UNITED STATES PATENT AND TRADEMARK OFFICE

APPLICATION NO.	FILING DATE	FIRST NAMED INVENTOR	ATTORNEY DOCKET NO.	CONFIRMATION NO.
09/476,521	01/03/2000	Herbert Gropp	RUM212	7964

Office Action Summary

1. The request filed on March 29, 2002 for a Continued Prosecution Application (CPA) under 37 CFR 1.53(d) based on parent Application No. 09/476,521 is acceptable and a CPA has been established. An action on the CPA follows.

Fig. 1

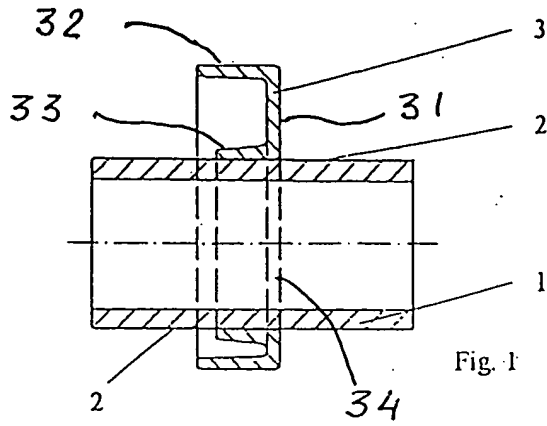
(C) The corrected Fig. 1 has been approved.

(a) the drawings should show the plane upon which a sectional view such as Fig. 1 is taken; and

Fig. 2

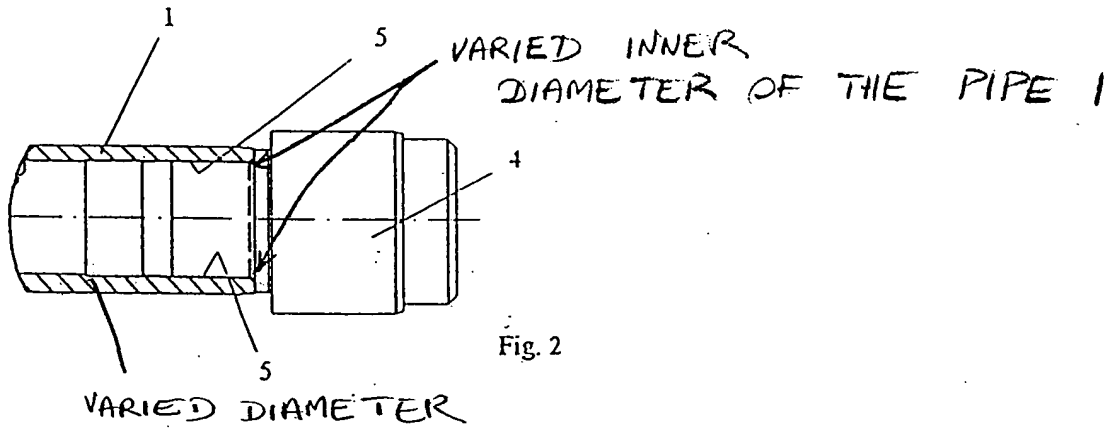
(a) new Fig. 4 introduces new matter such as the end piece 4 as now shown. The original Fig. 2 shows that the inner diameter of the pipe 1 is varied: (1) at the junction of the end piece 4 and the pipe 1 as shown by applicant's phantom line; and (2) at referential numeral 1 (see attached Exhibit). However, Fig. 4 shows that the inner diameter of the pipe 1 is constant. The

Fig. 3

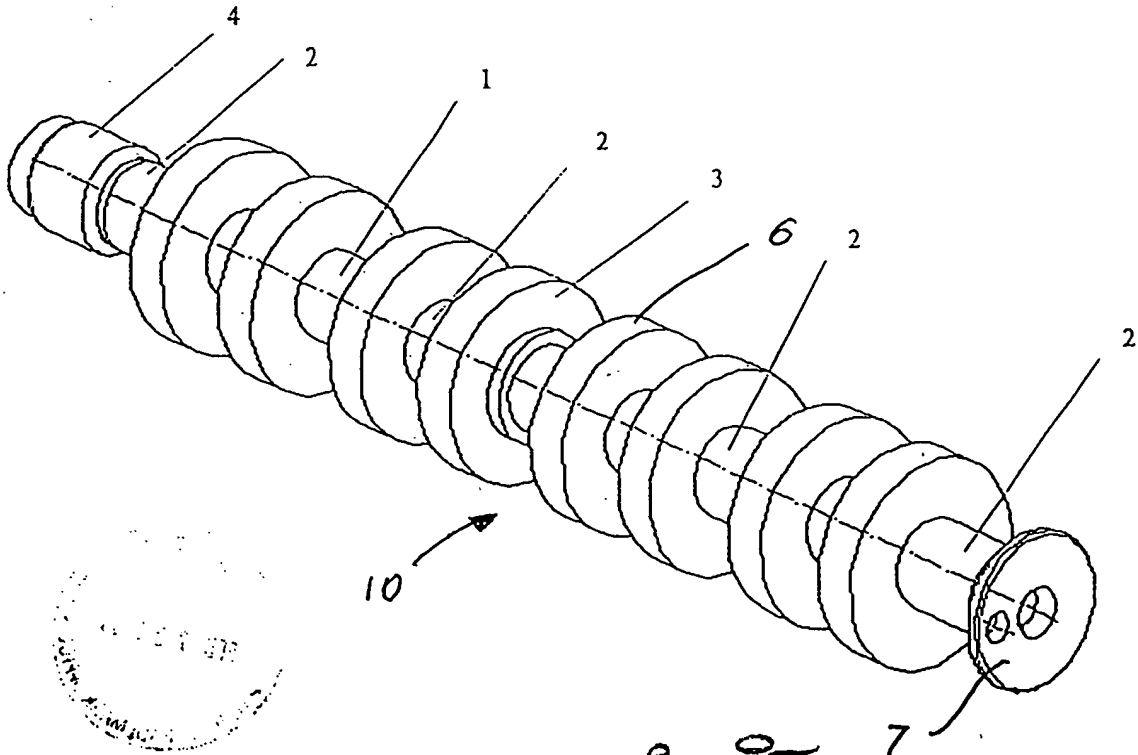
(B) The corrected Fig. 3 has been disapproved since it introduces new matter. The original drawings do not show the bearing rings. The corrected Fig. 3 now shows the bearing 6 which is identical to the cam 3. The showing and description of a specific type of bearing within a full spectrum of possible bearings is considered under the present disclosure to be new matter. *Cf., In re Smith*, 173 U.S.P.Q. 679 (CCPA 1972) and *Ex parte George*, 230 U.S.P.Q. 575, 578 (Bd. Pat. App. & Inter. 1986).

Not
Approved
VL
10/20/00

Fig. 4

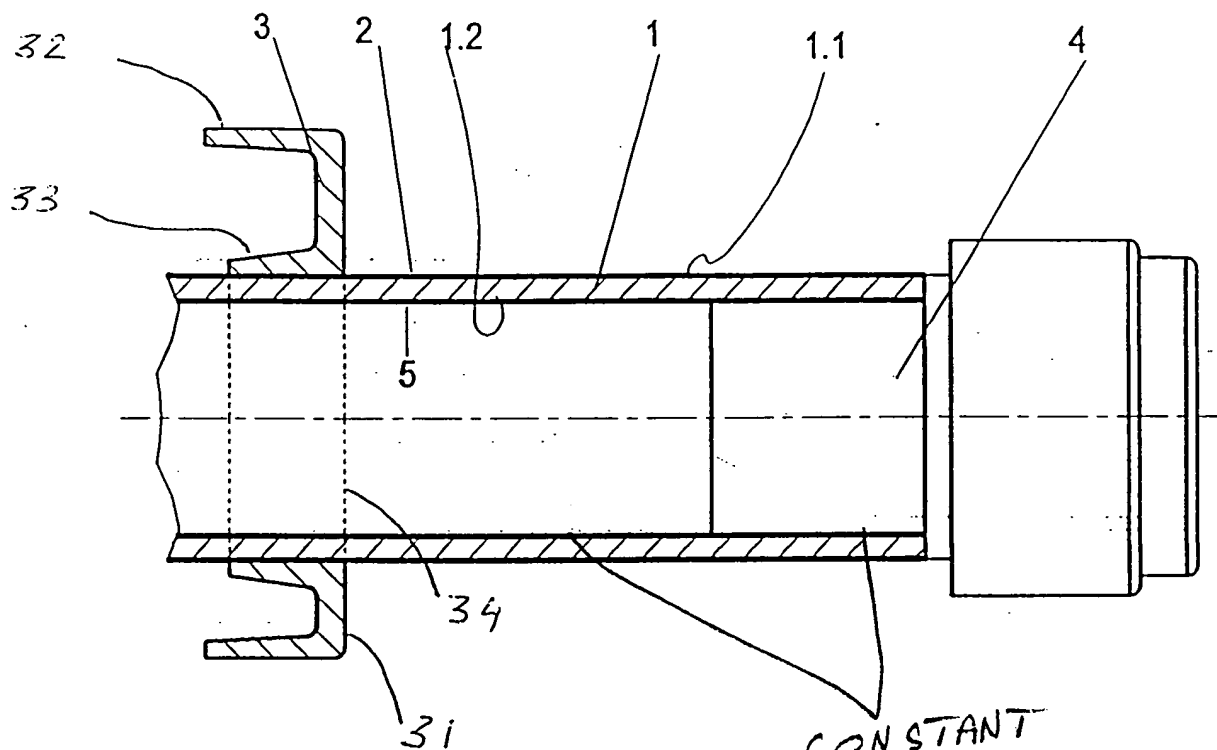
(b) new Fig. 4 is inconsistent with the description in Paper No. 9. The insertion on page 6, line 12 of the specification, states that the outer diameter of the end piece 4 is slightly larger than an inner diameter of the pipe 1. However, Fig. 4 shows that the outer diameter of the end piece 4 is equal to the inner diameter of the pipe 1.

Disapproved
VL
10/20/00

CONSTANT
DIAMETER
(NEW MATTER)
